Access Compliance Report

Public Rights-of-Way

(Curb Ramps)

Intersection ID: N/A	Main Street: COMMUNITY_HOUSE_RD	Cross Street: N/A	Location: W
ADA ID: 533AF3C19172	Ramp Type: Perp	Initial Pass/Fail: Fail	Overall Compliance: No
Severity Score: 1.25			
Codes/Mitigation Info/Possible Solution		Field Measurements/Component Compliance

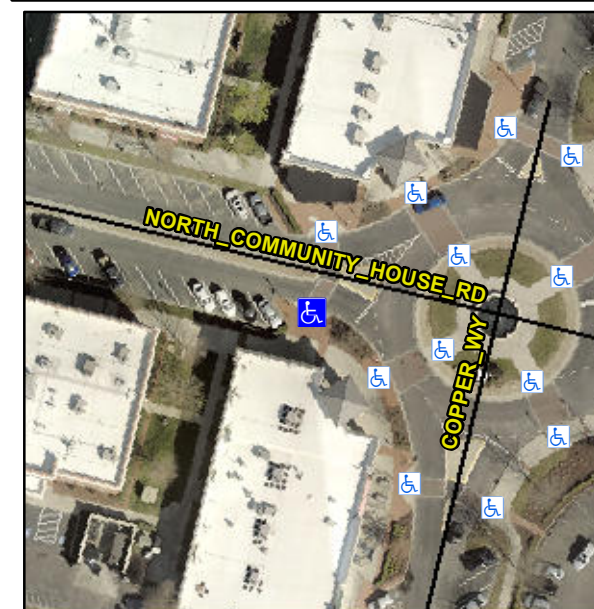
R304.5.3

Compliance	Description	Data	Compliance	Description	Data
N/A	Ramp Length (in)	204.0	Yes	Ramp Slope (%)	5.6
Yes	Ramp Width (in)	116.0	No	Ramp XSlope (%)	2.7
N/A	Flare Type LT	N/A	N/A	Flare Type RT	N/A
N/A	Flare Slope LT (%)	N/A	N/A	Flare Slope RT (%)	N/A
N/A	Flare Traversable LT?	N/A	N/A	Flare Traversable RT?	N/A
N/A	Landing Length (in)	N/A	N/A	DWS Provided?	N/A
N/A	Landing Width (in)	N/A	N/A	DWS Contrast?	N/A
N/A	Landing Slope (%)	N/A	N/A	DWS Length (in)	N/A
N/A	Landing X Slope (%)	N/A	N/A	DWS Full Width?	N/A
N/A	Landing Curb? (Y/N)	N/A	N/A	DWS Offset (in)	N/A
N/A	Shared Landing?	N/A			
N/A	Gutter Ponding?	N/A	N/A	Gutter Slope (%)	N/A
N/A	Gutter Lip Ht (in)	N/A	N/A	Gutter X Slope (%)	N/A
N/A	Painted X Walk1?	Yes	N/A	Painted X Walk2?	N/A
	X Walk 1 Direction	To N		X Walk 2 Direction	N/A
N/A	X Walk 1 Width (in)	99.0	N/A	X Walk 2 Width (in)	N/A
	X Walk 1 Slope (%)	1.7		X Walk 2 Slope (%)	N/A
	X Walk 1 X Slope (%)	1.4		X Walk 2 X Slope (%)	N/A

Remove & Replace Entire Ramp.
